GEMINI PROJECT

EA Application: Response to Secondary Information Request

MAGNETIC SOUTH

AUGUST 2021

Figure 1: Revised conceptual project layout and location of adjacent sensitive receivers

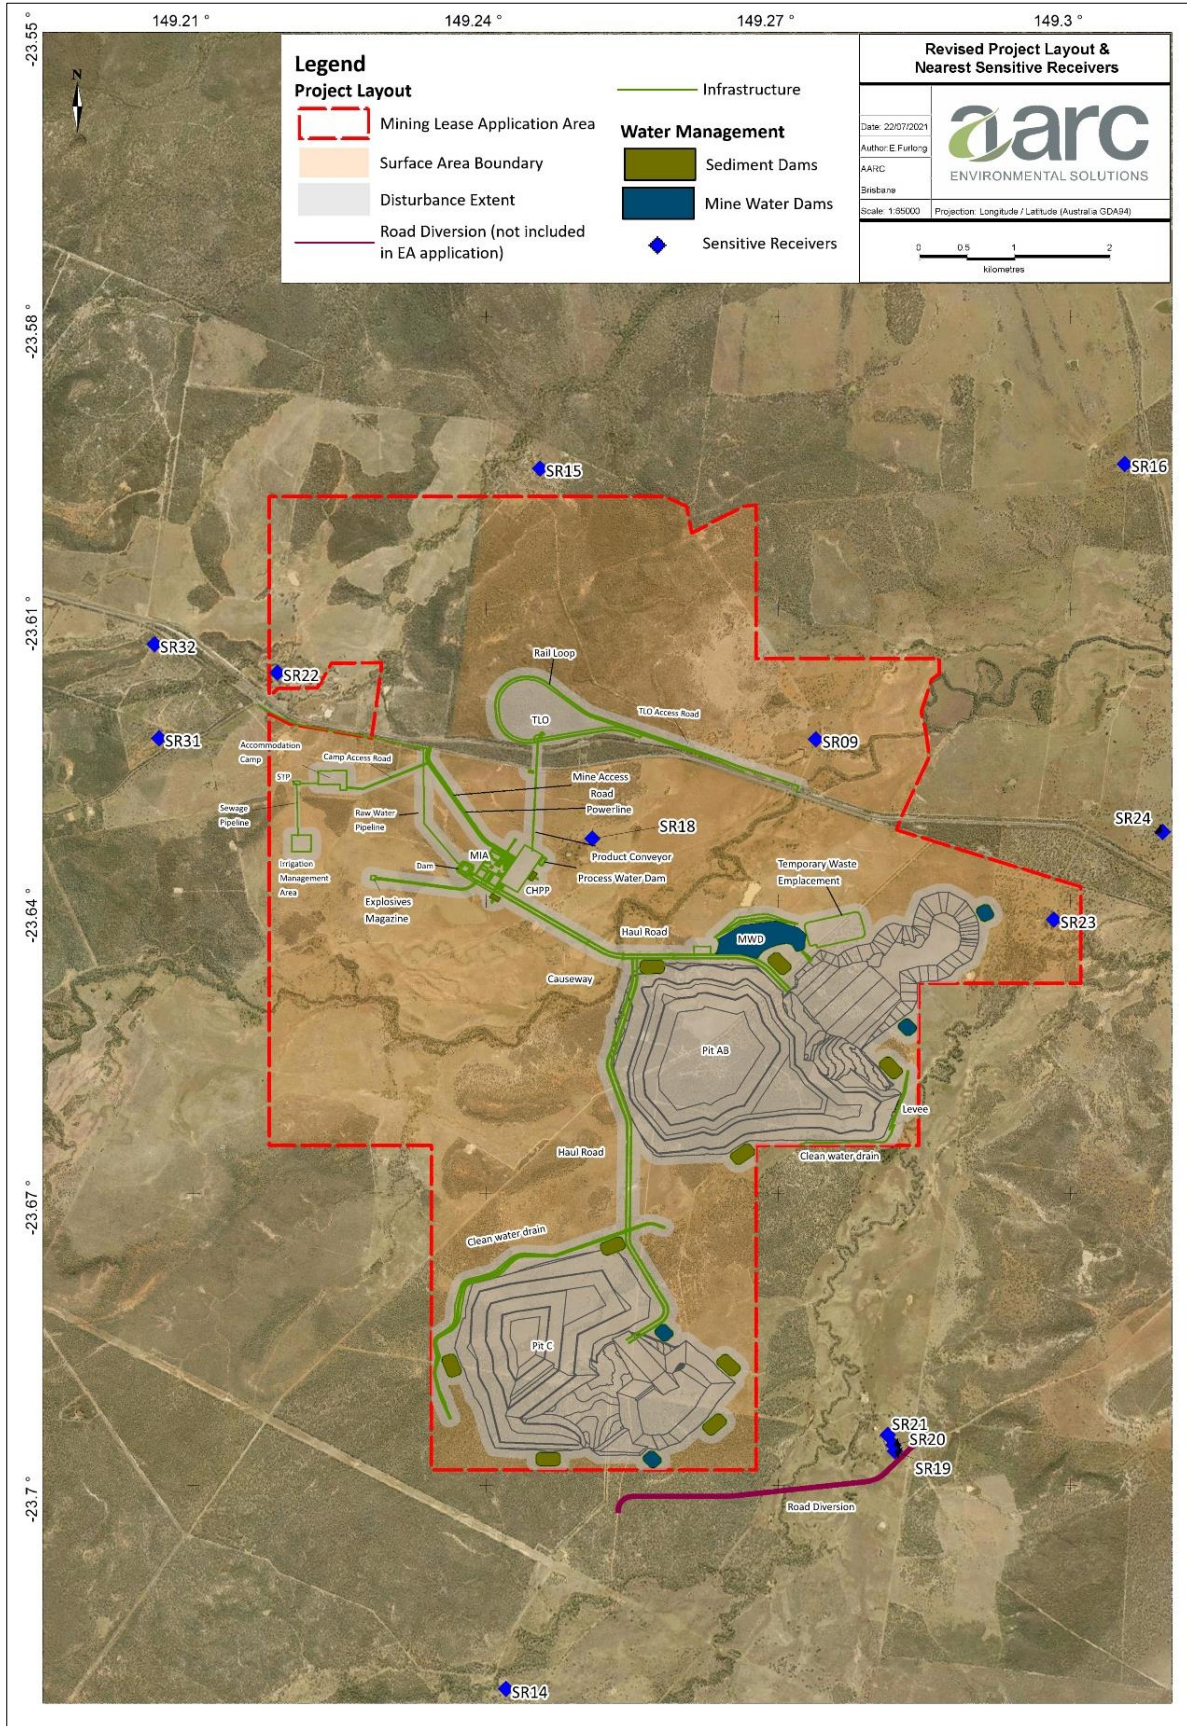
Figure 7 - Conceptual Layout of the Gemini Project shows that the crest of the high wall on the southern end of the Pit AB final void is proposed to extend right to a corner boundary of the tenure, MLA 700056. Table 7 states that a 100 metre buffer has been included around the perimeter of the disturbance footprint, but it is not clear if the buffer has been applied to this part of Pit AB final void area. The Revised Supporting Information does not sufficiently address information requirements, such as, the expected geotechnical stability of the final battered high wall and potential liability of high wall failure. The assessing officer's concern is that as the final landform is proposed to be so close to the tenure boundary, there is a possibility that high wall failure may cause impacts outside of the tenure boundary.

Provide further information to justify the position of the final void for Pit AB with regard to the concerns of creating disturbance and impacts to environmental values (EVs) outside of the tenure boundary. Alternatively, provide a revised conceptual project layout that includes an appropriate buffer between the battered high wall of Pit AB final void and MLA 700056 boundary.

Figure 7 in Section 3.1 of the *Revised EA Application Supporting Information* shows the conceptual project layout, including a 100m buffer within which disturbance may occur (also shown in Figure 1 of this report). The authorised disturbance areas provided in Table 7 include this 100 m buffer. The purpose of this 100 m buffer is to provide design flexibility for activities that may require disturbance beyond the original design infrastructure footprint. This 100m disturbance area has been reduced on the eastern edge of the AB Pit, due to the proximity of the mining lease (ML) boundary. The eastern edge of the AB Pit will be located approximately 50m from the edge of ML during mine operations, and the top of the final battered highwall (following backfill, regrading and rehabilitation activities) will be located approximately 15m from the edge of lease.

The conceptual mine plan was based on preliminary geotechnical studies completed for the Project. The excavated eastern high wall slopes were designed to achieve a factor of safety of 1.3 during mine operations (refer to Table 1). The highwall slopes will then be flattened during rehabilitation, in order to achieve a stable post mining landform.

These minor changes will not result in significant changes to the mine plan layout and the location of the highwall in relation to the mining lease will remain unchanged to that which is shown in Figure 1.

Figure 2: Location of monitoring bores and water gauge stations

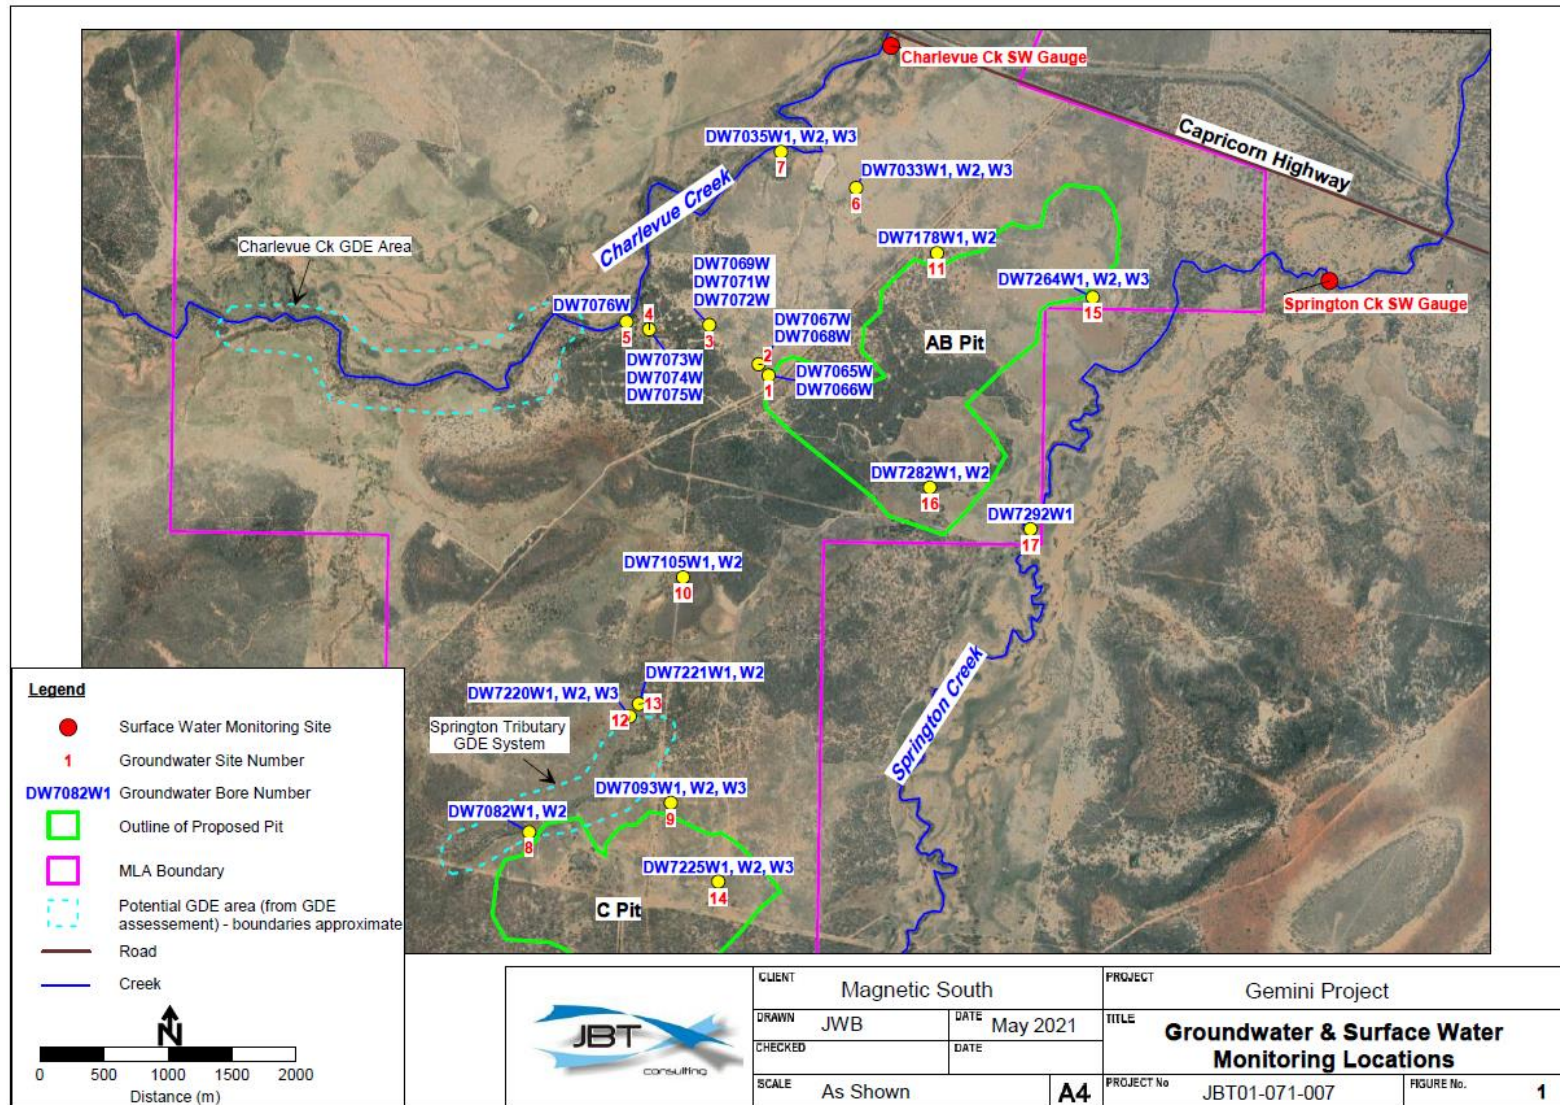
Provide the date of installation of the downstream flow gauging and water quality monitoring stations.

Provide the stream flow and water quality data that has been collected to date.

The location of existing groundwater monitoring bores and surface water gauging stations, along with identified potential GDE areas in the project area, are shown in Figure 2.

- There are already a number of existing nested bores installed in the Tertiary and Permian groundwater in/ adjacent to the Springton Creek Tributary System GDE (DW7220, DW7221, DW7082, DW7093) (refer to Figure 2). Site DW7082 has been identified as a suitable location to install an alluvium bore, which would

provide a better understanding of the relationship between the alluvium and the underlying groundwater units in this location. This would also provide an additional impact monitoring bore for Pit C (also outlined in Section 4.3.3.3).

Figure 4: Groundwater level in, and base of, Tertiary sediments

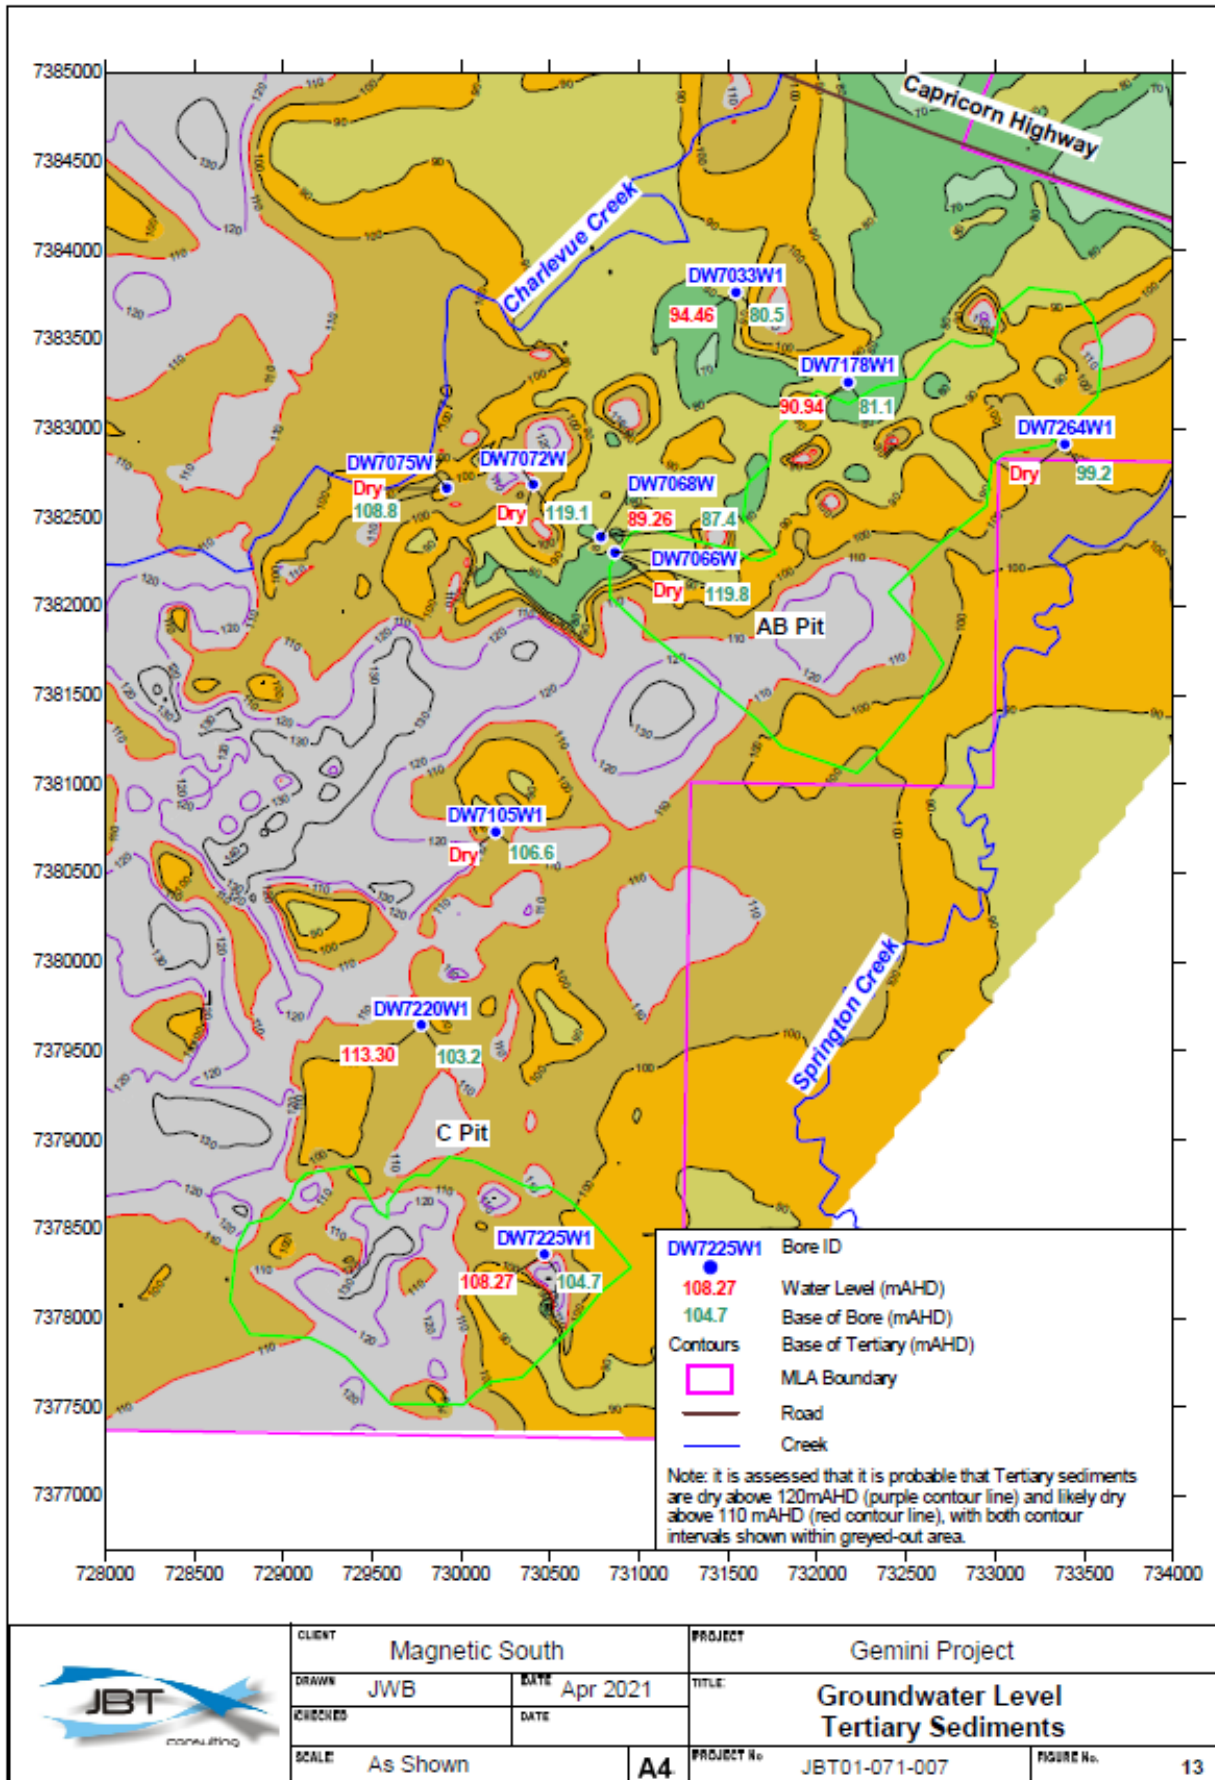
Detailed conceptual understanding of the direction of groundwater flow needs to be demonstrated. Provide a figure illustrating ground water level contours indicating directional flow of groundwater. To demonstrate that the bore network is entirely representative of up and down gradient for each groundwater unit, produce a figure that visualises the ionic chemistry of the groundwater samples, for example, a piper diagram.

A map of the elevation base of the Tertiary sediments (based on data for the site geological model) and the water level data for Tertiary sediment monitoring bores is provided in Figure 4. The Tertiary groundwater system in the ML area is shown to be intersected by a Permian ridge (shown in Grey), which separates the northern and southern parts of the mining lease. The groundwater flow direction in the Tertiary sediments in the ML area is therefore interpreted as being quite localised – moving towards the areas of lower Tertiary base elevation from areas where the preferential recharge occurs (e.g. the area around bore DW7220W1 (refer to Section 2.1.2 of Appendix B. A more detailed analysis is provided in Section 2.1.3 of Appendix B.

Figure 6: Proposed Post Mining Land Use (PMLU) LSC for cattle grazing

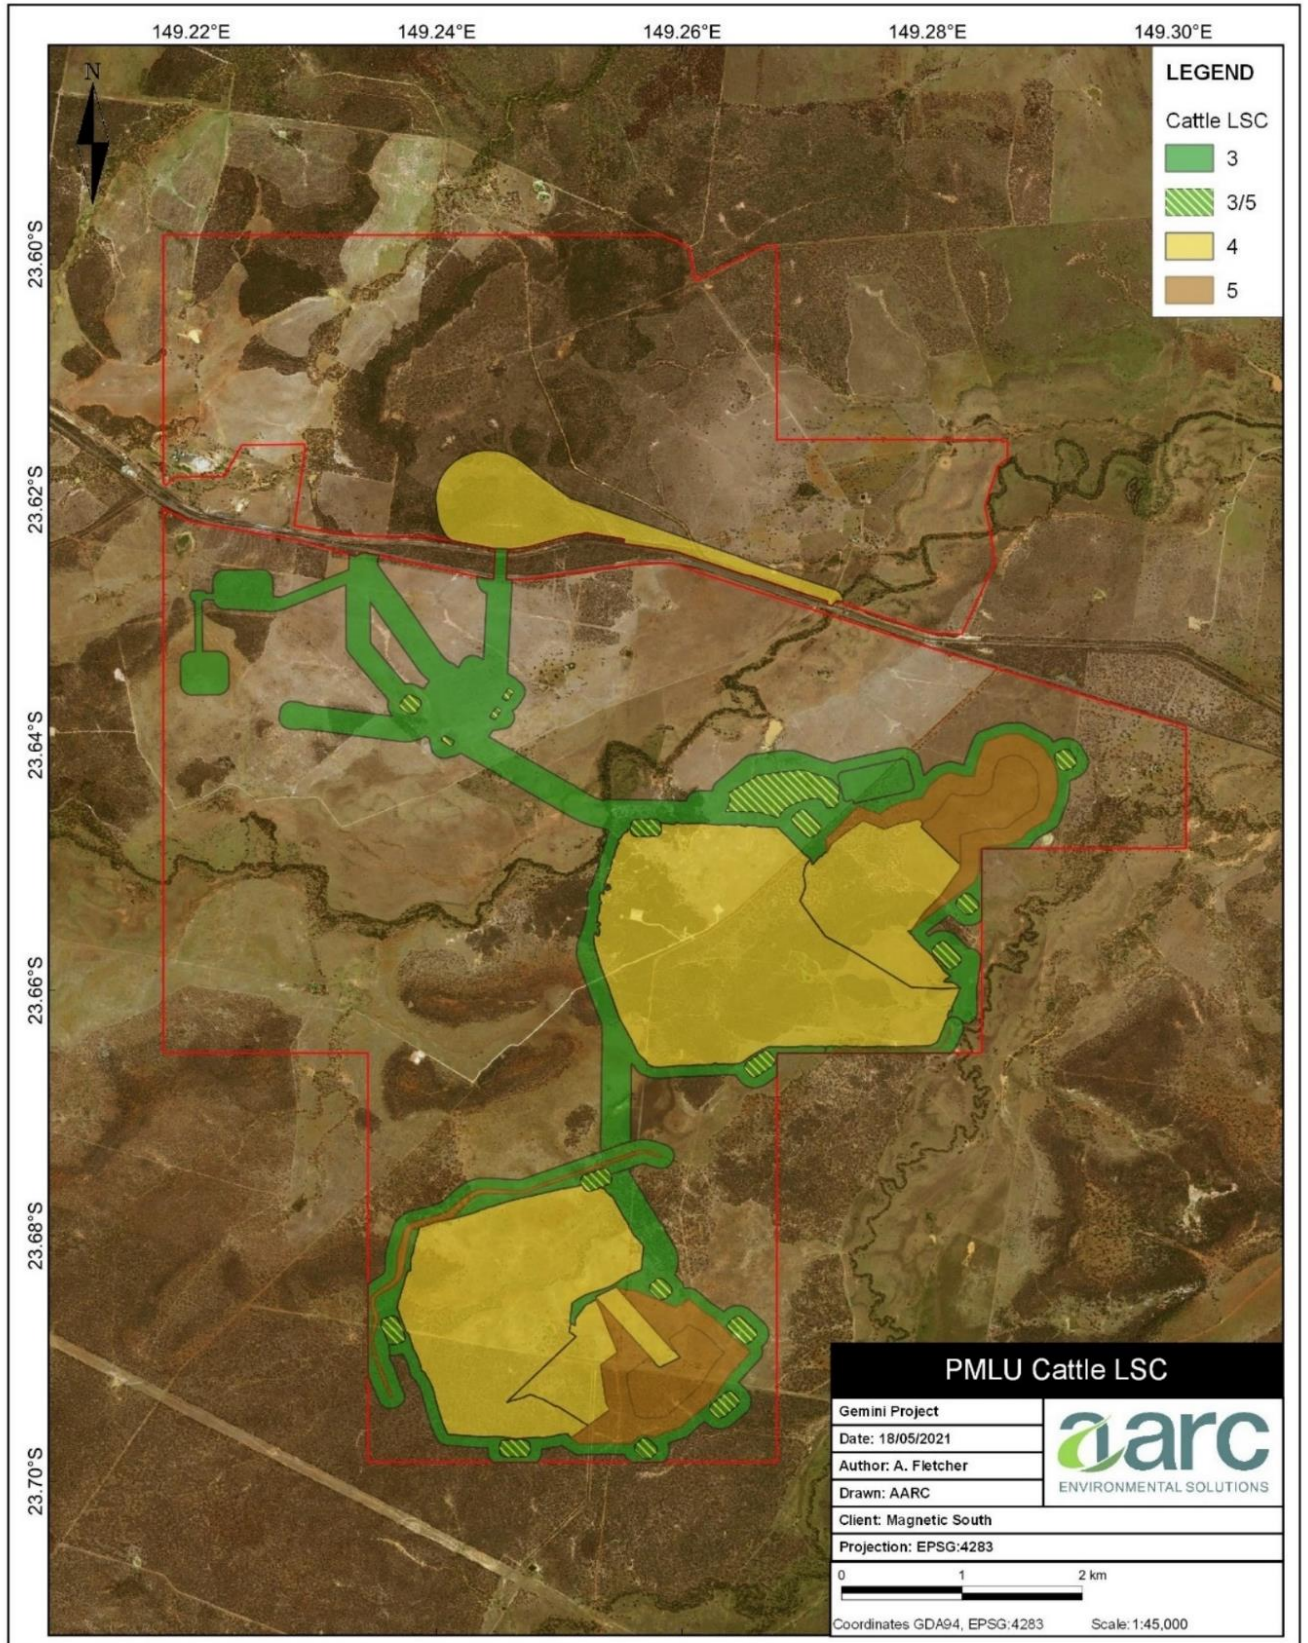
Provide more detailed explanation and acceptance criteria for the post-mining land use “grazing”, particularly:

- The land suitability class/es that will be achieved for areas with a post mining land-use of “grazing”, including if it will return to pre-mining land suitability class or different
- If an area will have a different class to pre-mining, provide justification for how the proposed post-mining land suitability class is appropriate
- If “grazing” will achieve varying land suitability classes in the post-mining landform, provide proposed areas and locations for each class
- Given land suitability classes are assessed against limitations, provide the parameters that will demonstrate that an area has achieved the proposed post-mining land suitability class.

The post mining cattle grazing Land Suitability Class (LSC) proposed to be achieved for each mine domain is shown in Figure 6. This was determined based on the *Land Suitability Assessment Technique* (DME 1995)), with consideration of the pre-mining LSC (refer to Figure 7 SLSA Assessment) and physical characteristics of the post mining landscape, such as topography, recreated soil profiles and the underlying substrate (e.g. mine waste).
